# UNITED STATES PATENT AND TRADEMARK OFFICE

APPLICATION NO.	FILING DATE	FIRST NAMED INVENTOR	ATTORNEY DOCKET NO.	CONFIRMATION NO.
10/815,594	04/01/2004	Thomas Bethge	5562-104US	1155

# Office Action Summary

## DETAILED ACTION

Fig. 3

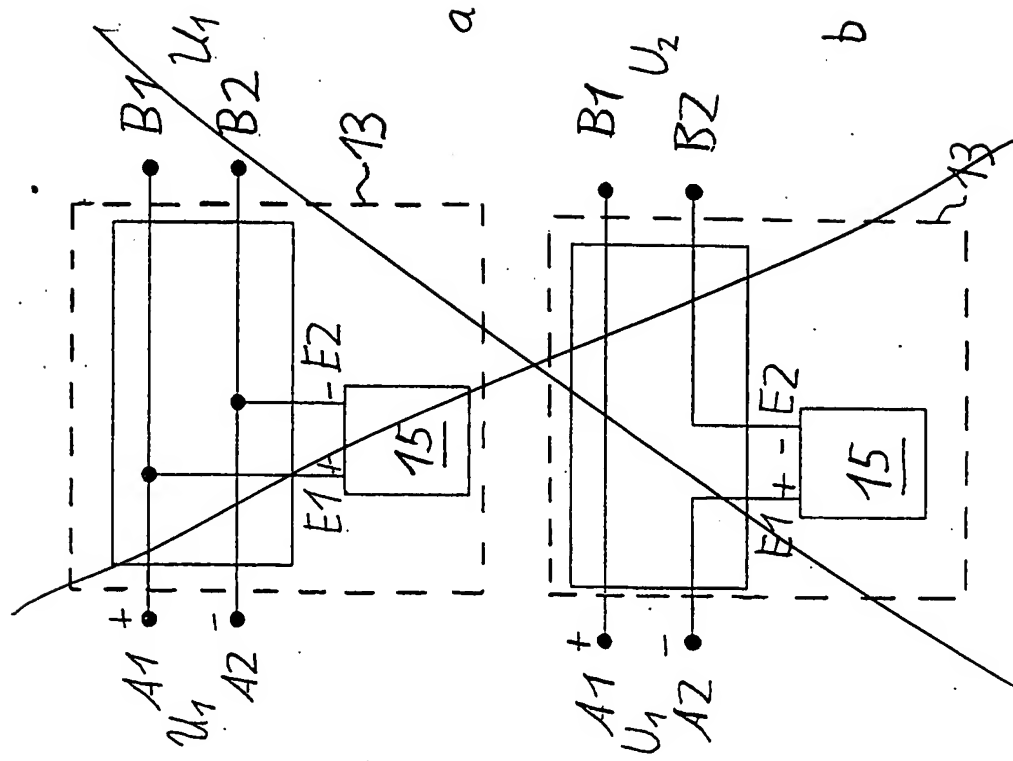
1. The drawings were received on 8/27/07. These drawings are approved.
2. Also, applicant indicated on page 9 of the 8/27/07 response that the second Figure 3 is deleted, but no indication of this was made in the drawing corrections. Hence, the examiner is enclosing an approved photocopy of the canceled Figure 3.
3. The drawings are objected to under 37 CFR 1.83(a). The drawings must show every feature of the invention specified in the claims. Therefore, the sliding roof adjusting device and window lifting device (claim 7) must be shown or the feature(s) canceled from the claim(s). No new matter should be entered.
